Forsyth County Procurement

ADDENDUM #6

RFP 20-78-1620

For: Providing all labor, equipment and materials for the construction of a new Juvenile Justice Center at 875 Lanier 400 Parkway, Cumming, GA 30040. Project includes a multi-phased site development, demolition of existing motel structures and construction of new 62,000 square foot Juvenile Court building.

5 CURTAINWALL SILL DETAIL
SCALE: 3" = 1'-0"

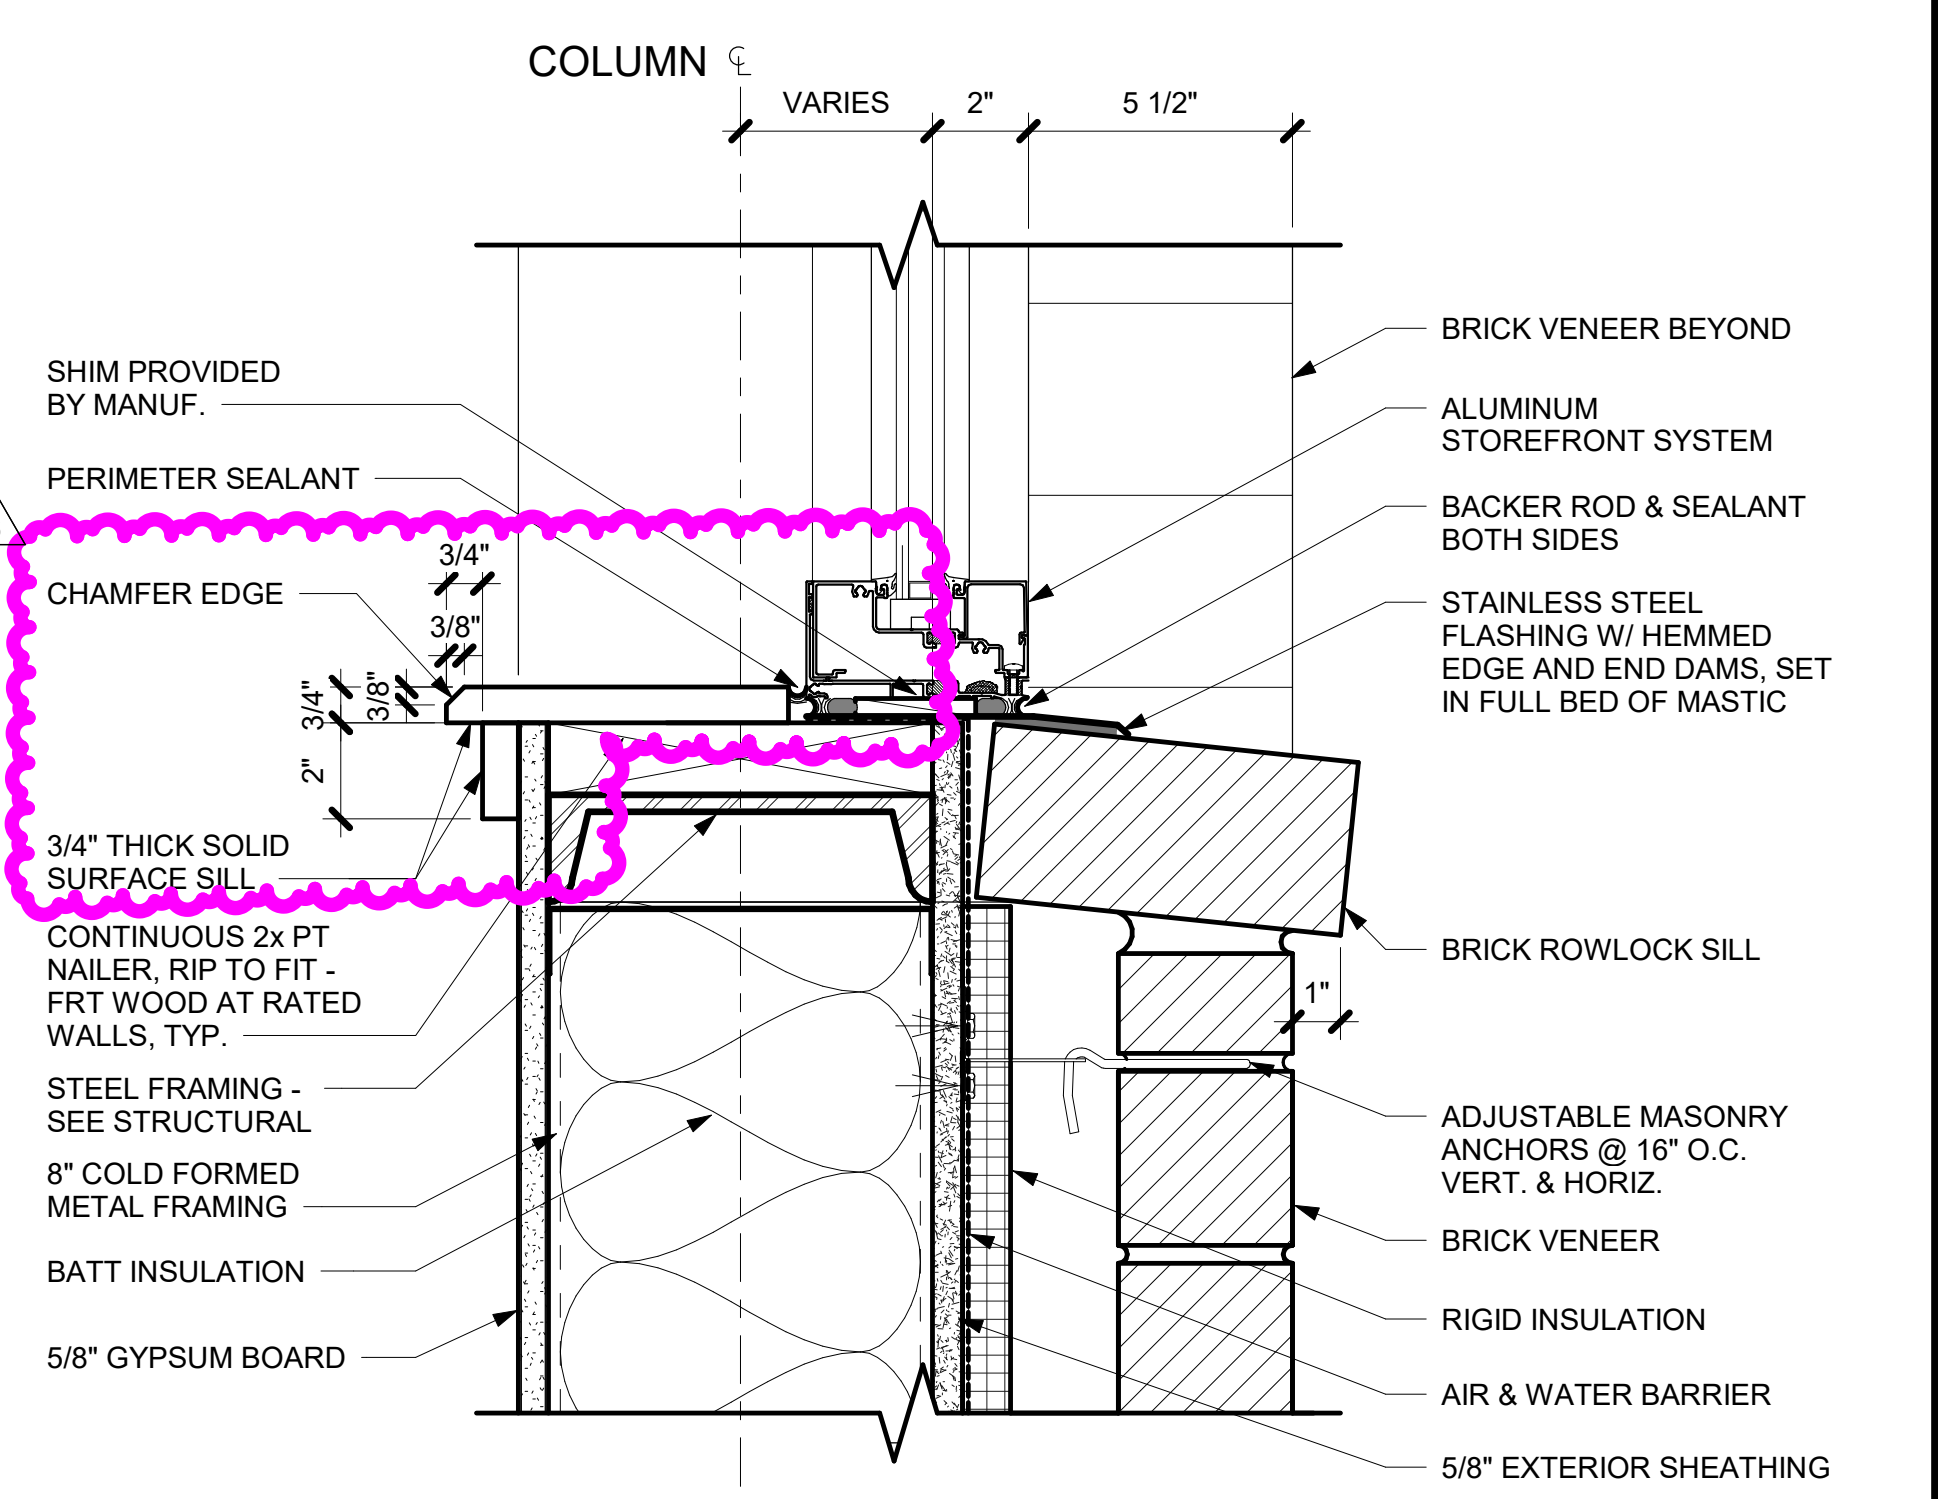
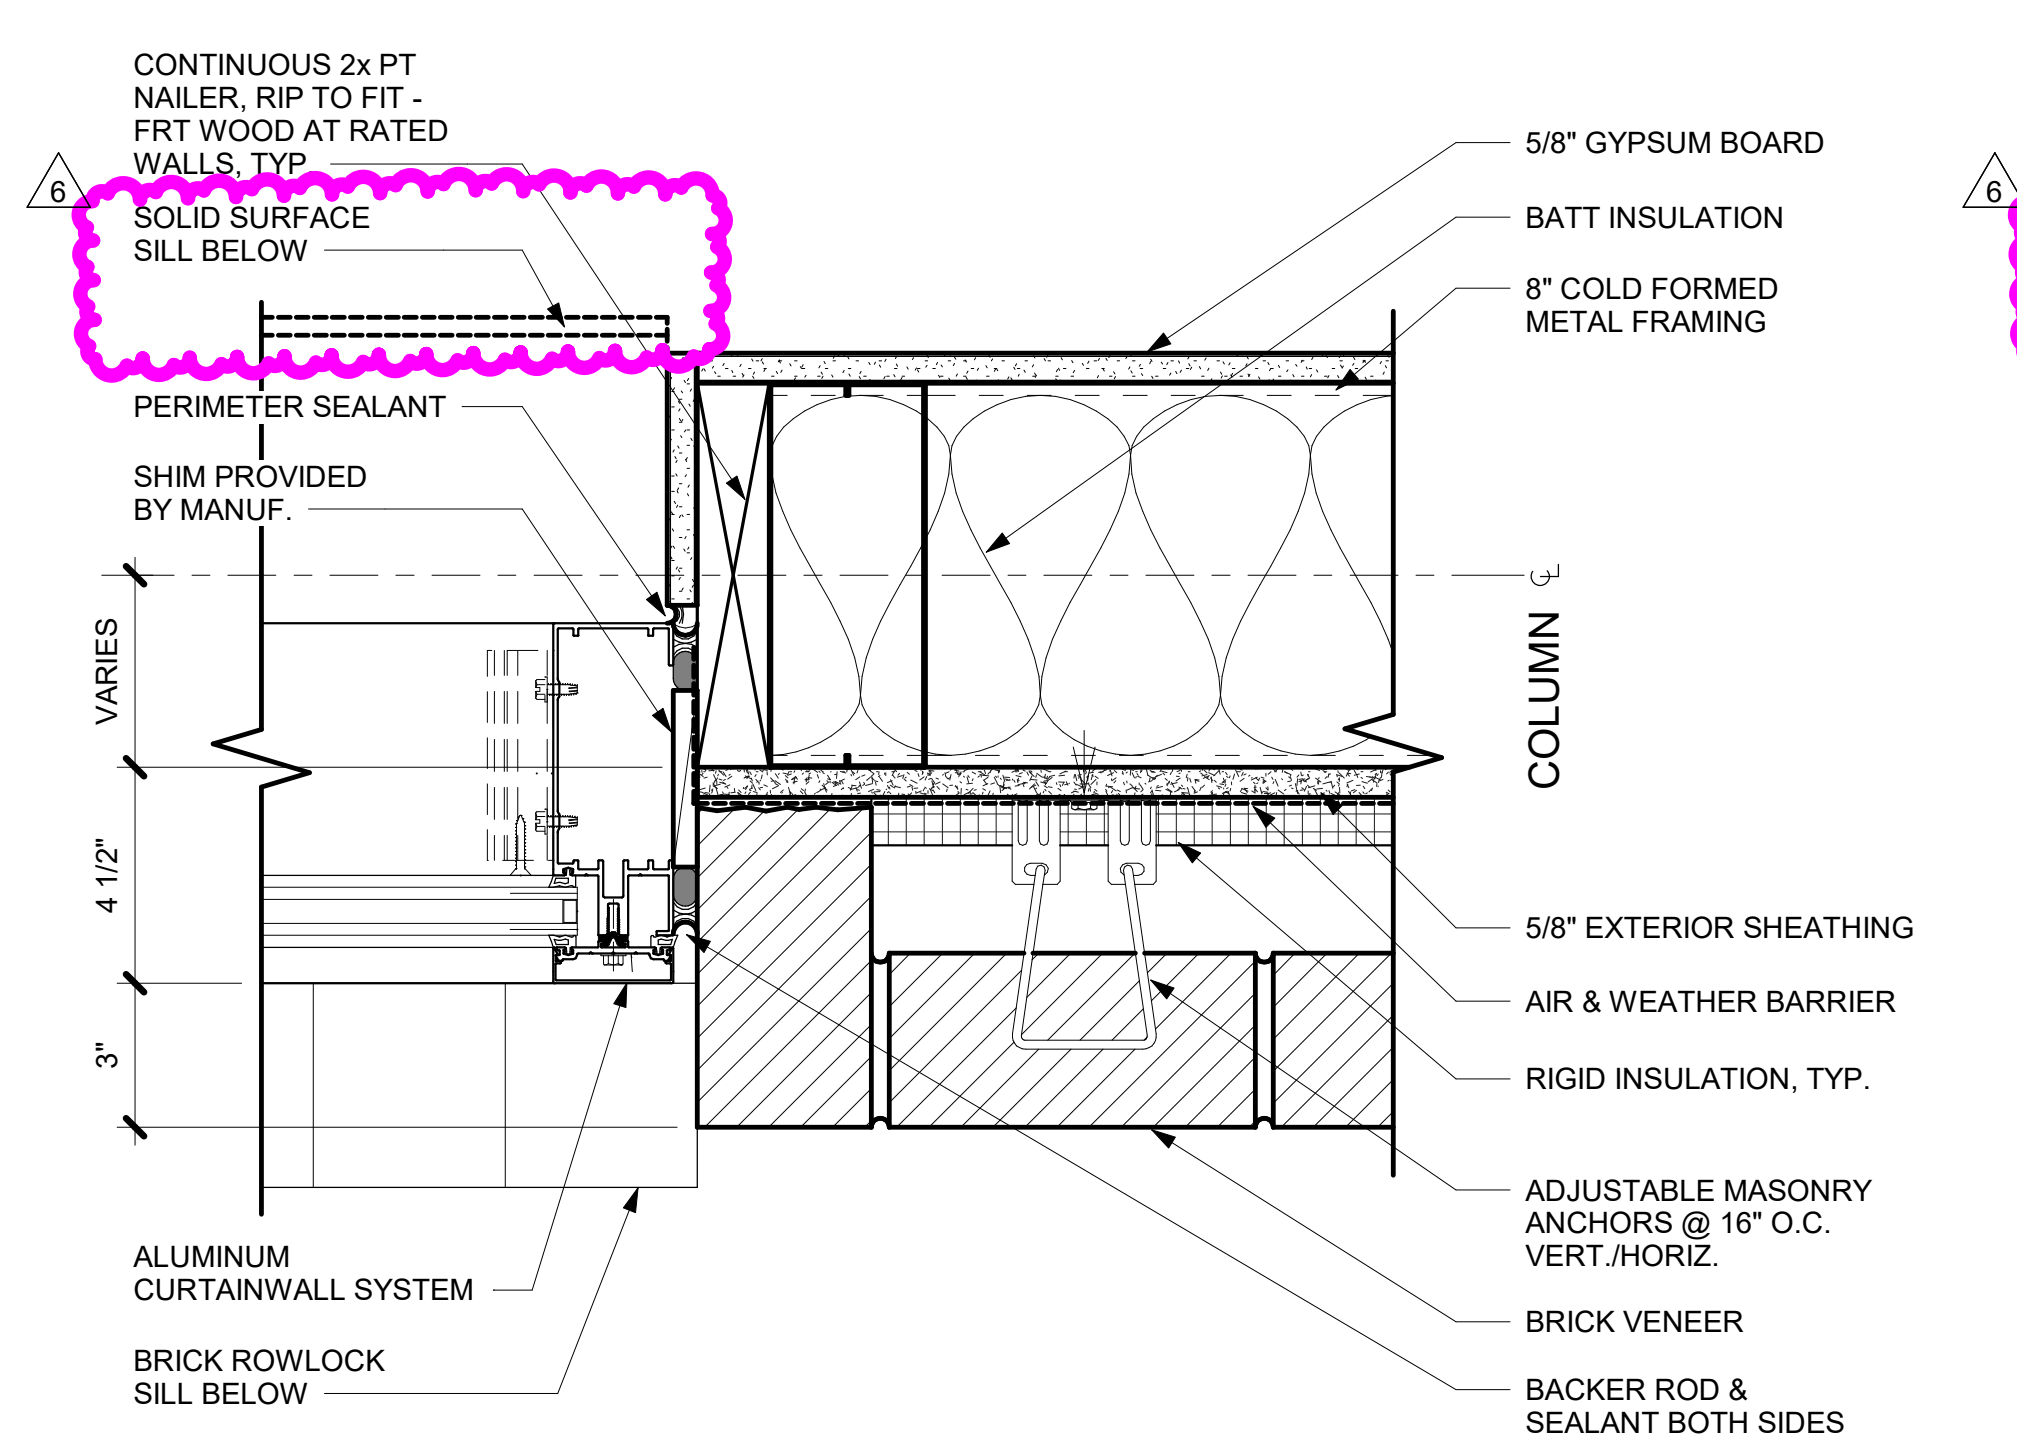
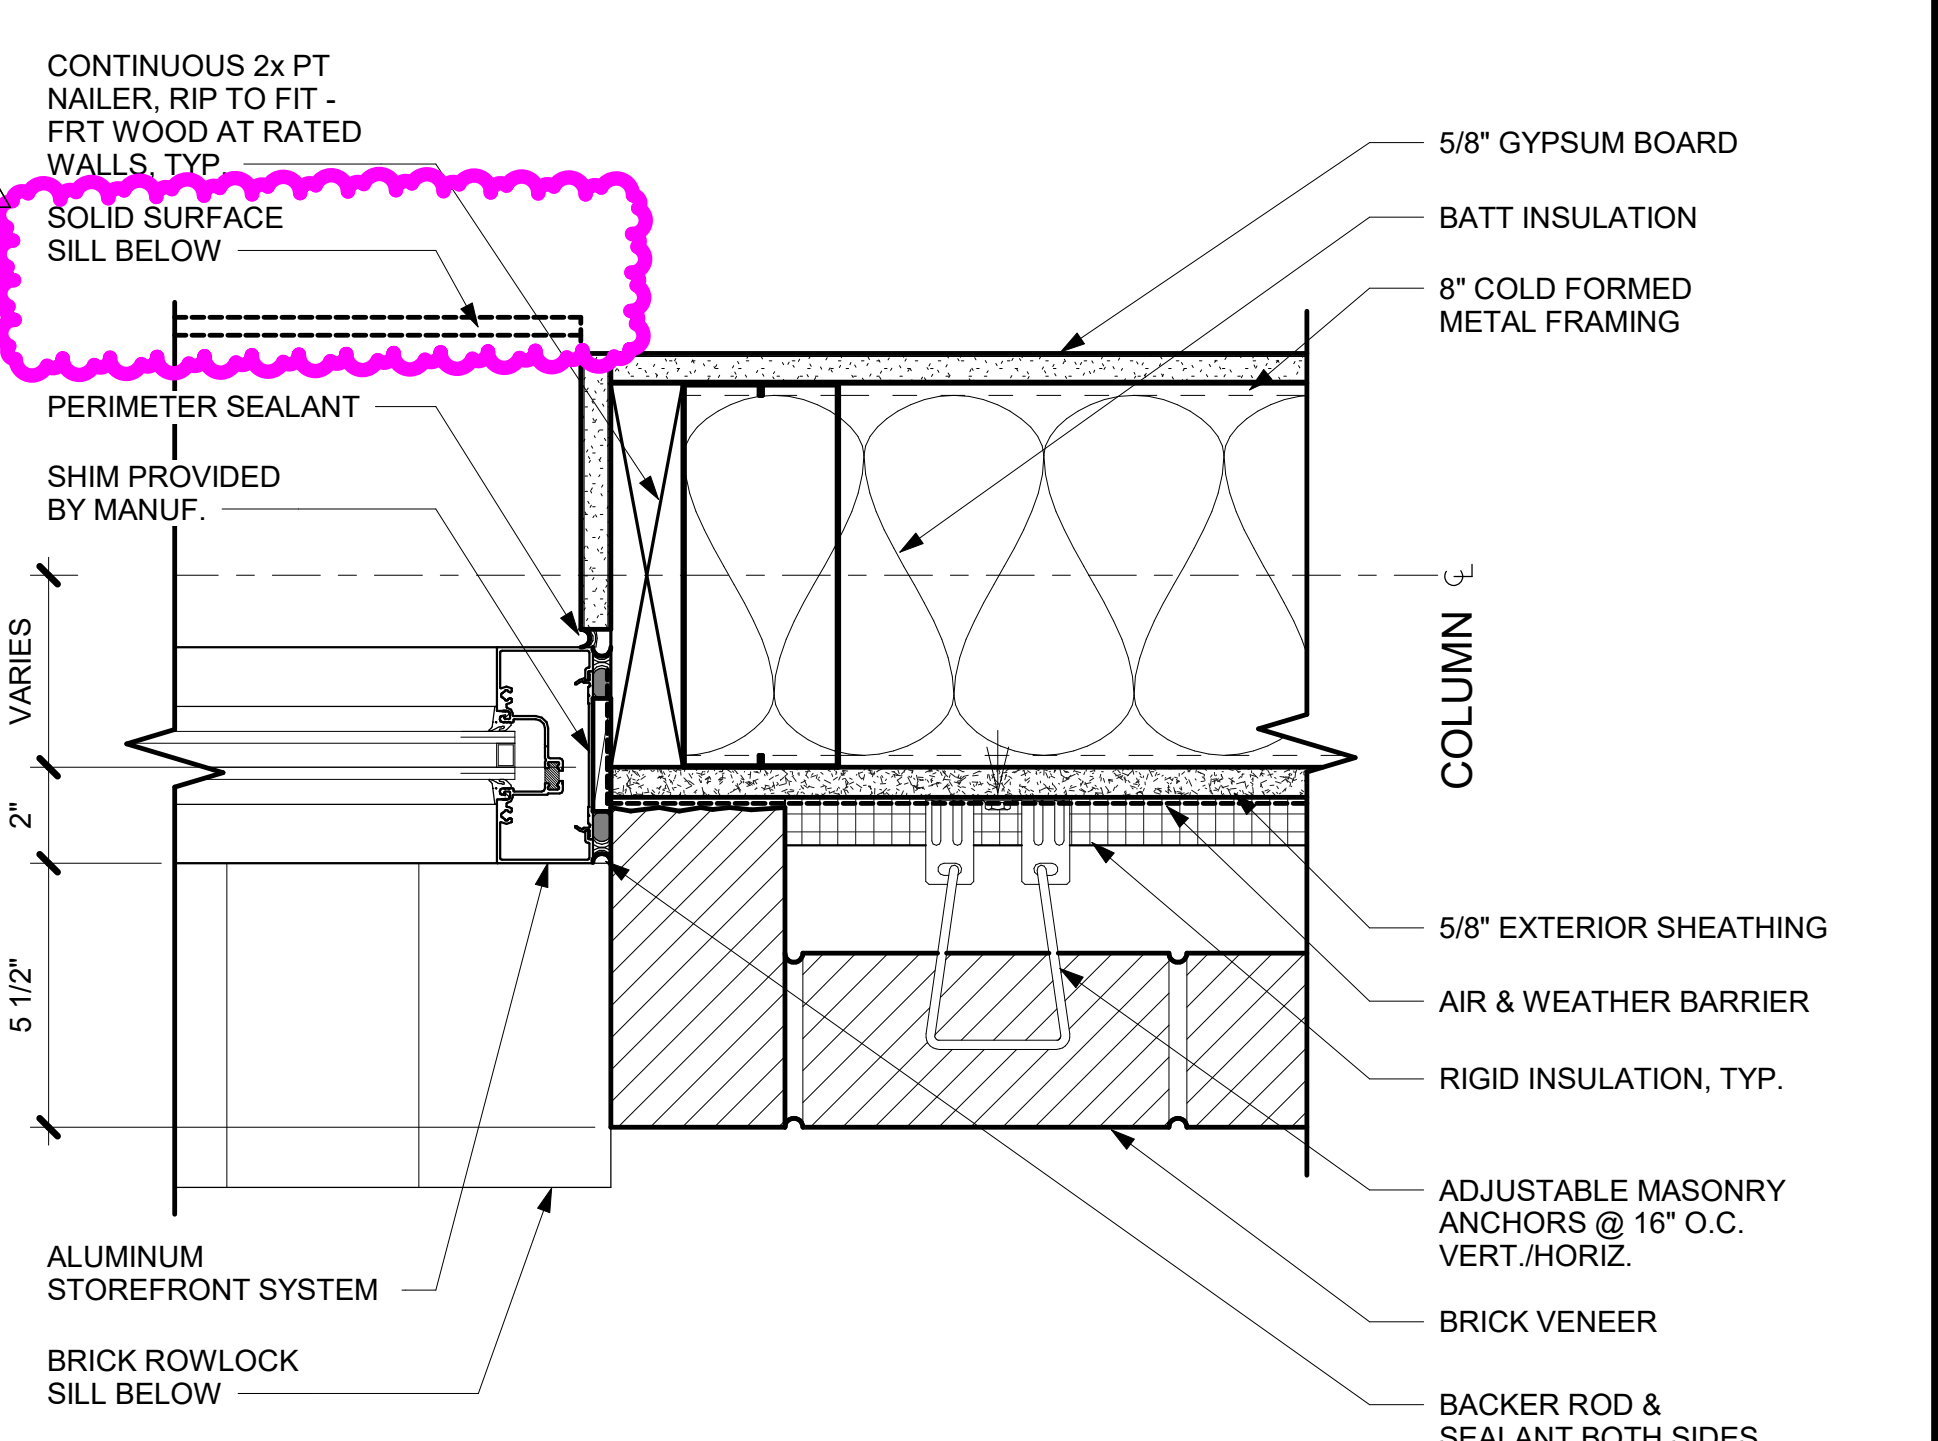
- 2-10 Sheet A-7.61 WINDOW DETAILS:
1. Revised sill details to show trim.
